HYUNDAI Technical Service Bulletin

Group	BODY (INTERIOR/EXTERIOR)
Number	09-BD-007
Date	JULY, 2009
Model	2010 GENESIS COUPE(BK)

Subject
GENESIS COUPE (BK) DOOR BELT WEATHERSTRIP CHANGE

Previous		New

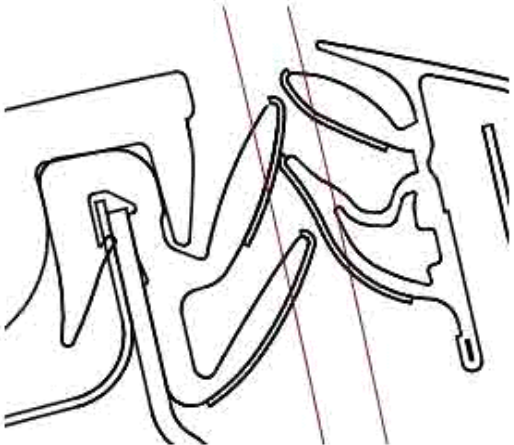
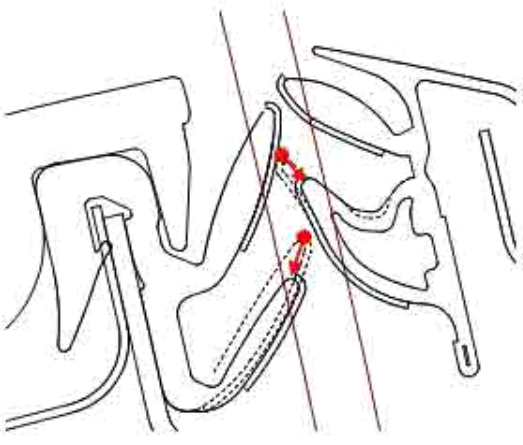
- Lower lip of inside door belt weatherstrip has been cut by 4 mm.
- Lower lip of outside door belt weatherstrip has been cut by 4.5 mm.

Door belt - Inside	82231 - 2M0009P (LH) 82241 - 2M0009P (RH)	Door belt - Inside	82231 - 2M0019P (LH) 82241 - 2M0019P (RH)
Door belt - Outside	82210 - 2M000 (LH) 82220 - 2M000 (RH)	Door belt - Outside	82210 - 2M001 (LH) 82220 - 2M001 (RH)

NOTE: The previous door belt weatherstrips are not available as service parts. When the replacement of a door belt weatherstrip is required, use a new type replacement part.
